## ***Interactive comment on “Development of a Precipitation-Area Curve for Warning Criteria of Short-Duration Flash Flood” by Deg-Hyo Bae et al.***

Revision according to the reviewer's comments:

Fig. 1. Revised Figure 4

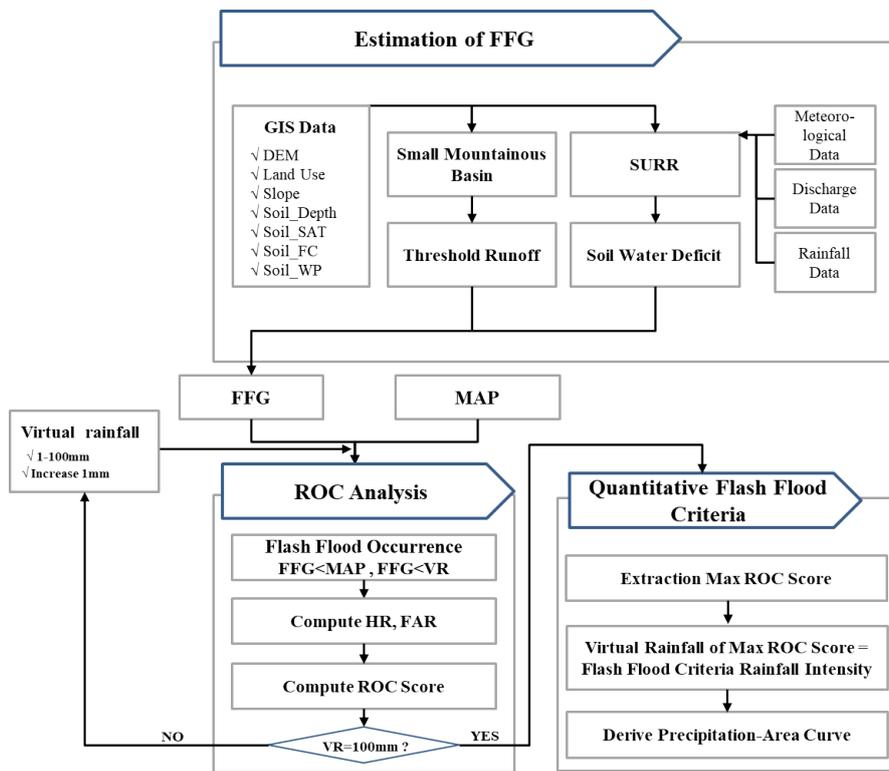
3. The methods section I found difficult to follow. You start of with QPC computation and briefly mention the concept of 'virtual rainfall'. Please elaborate more on that so that readers can reproduce the full stream of your methods. Provide (more) mathematical formulations where appropriate, and please do explain all parameters used (some

are not referred to). Why use bankfull discharge? Is that the definition for the minimum discharge to cause flash flooding? Assuming steady, uniform flow may also be problematic for flash floods, and you might want to pick that up in the discussion. Equation 3 shows a soil-water content balance that you adapt from the SURR model; how well can you constrain each of the five terms? For example, will evapotranspiration as a function of time be relevant for forecasting flash floods? Clearly you want to specify the timescales that you base your forecasts on. I was unsure about the output of your model. Your use of a receiver-operating-characteristic curve indicates that you classify something, but what exactly, remains vague. Please explain in more detail how you labeled the classes of observed events and how you predicted new classes using SURR.

9. Figures: #1 is OK, if you add some explanatory detail to the caption; please explain all abbreviations. #2 needs geographic coordinates and larger fonts. #3a and #4 need units for 'sub-basin area'; are #3b and #4b really necessary? Histogram bins in #5b may be too wide: what is it that you wish to state here? #6 needs explanations of color codes. #7 needs larger fonts and explanation of abbreviations. #8: it is unclear what the minimum and maximum numbers refer to. #9: please explain orange shades. #10: please explain red and blue circles. Overall, you may want to use your captions for informing readers more about the contents and messages of your figures.

-We revised Figure 1 to provide a more detailed description and added some explanation (page 4, line 5~12). This revision makes it clearer how we apply the ROC analysis and how we derive the P-A curve.

“This study presents a method for deriving a P-A curve that represents the rainfall thresholds occurring during flash floods. The method is based on FFG analysis to avoid the need to estimate soil moisture conditions. Figure 4 presents the overall procedure used to evaluate the quantitative precipitation criteria (QPC) for flash flood warning. First, the mean areal precipitation and FFG were calculated by using topographic, meteorological data for the sub-basins in the study area. To obtain FFG at current time (t), which is a summation of threshold runoff (TR) and soil moisture deficit, threshold runoff at each sub-basin is estimated. The soil moisture conditions from actual rainfalls are simulated by using SURR model, and we can decide whether a flash flood occurred at certain basin by comparing this FFG value and that from 1-hr prior to the actual rainfall. In this experiment, it is assumed that if the observed MAP is larger than the FFG, a flash flood occurs.”

-We revised Figure 1 to provide more detail. -We added the unit of sub-basin area in Figure 3 and Figure 4. -Figure 3b and 4b are necessary for the understanding of sub-basin area distribution. -The interval of the histogram bins of Figure 5b was changed from 5 to 3. -We added some explanation of the color codes in Figure 6 -We changed the font size and explained the abbreviations of Figure 7 -The minimum value of Figure 8 was revised -We explained the orange shades of Figure 9 and the red and blue circles in Figure 10
